# Groundwater Transfer Review Summary Form

Transfer/PA # T- 14151

Application: T-14151

Applicant Name: John and Loudean Elliott

### T-14151

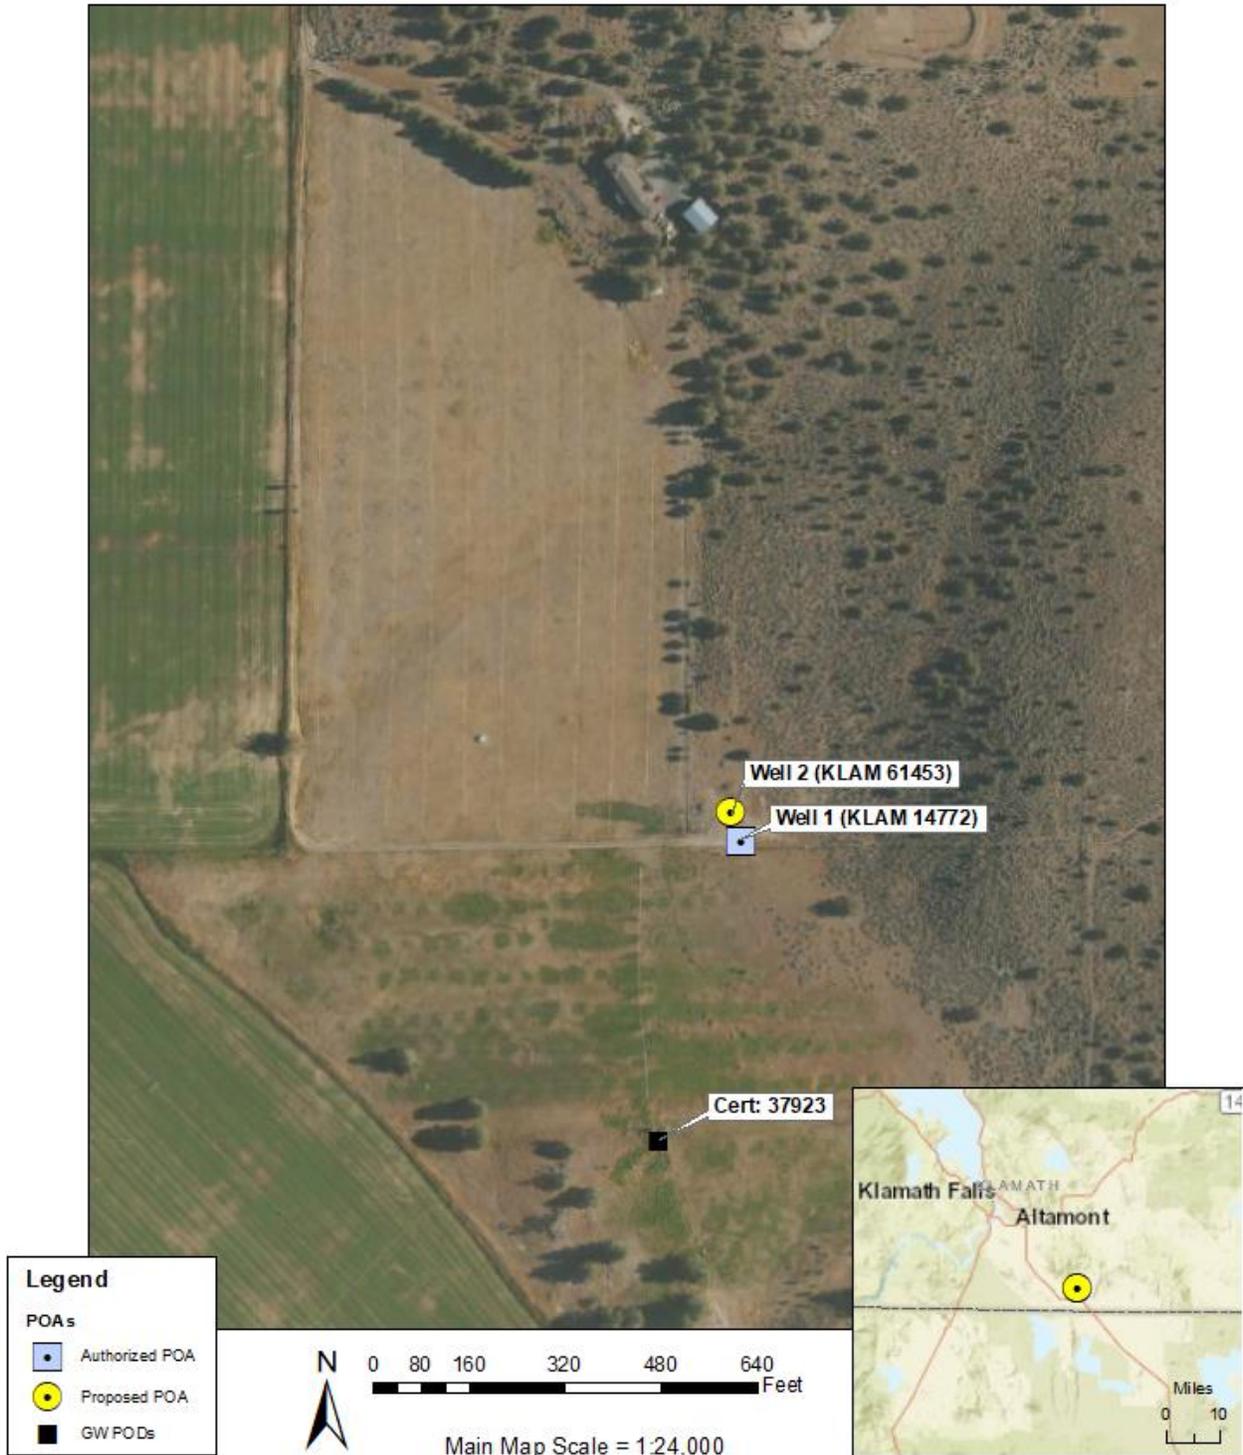
1. Basic description of the changes proposed in this transfer: The applicant’s previous authorized POA “Well 1” (KLAM 14772) associated with Certificate 65944 has gone dry. The applicant seeks to change the authorized POA to proposed POA “Well 2” (KLAM 61453). No POU changes are proposed.

2. Will the proposed POA develop the same aquifer (source) as the existing authorized POA?  
 Yes     No    Comments: Both authorized POA “Well 1” (KLAM 14772) and proposed POA “Well 2” (KLAM 61453) extend into Tertiary volcanics of the Winema Volcanic Field.

4. a) Will this proposed change, at its maximum allowed rate of use, likely result in an increase in interference with **another ground water right**?  
 Yes     No    Comments: The proposed POA “Well 2” is approximately 25’ feet away from the authorized POA “Well 1”. No change in interference with other water rights is expected.

Yes  No Comments: The proposed POA "Well 2" is approximately 25' feet away from the authorized POA "Well 1". No change in interference with another surface water source is expected.
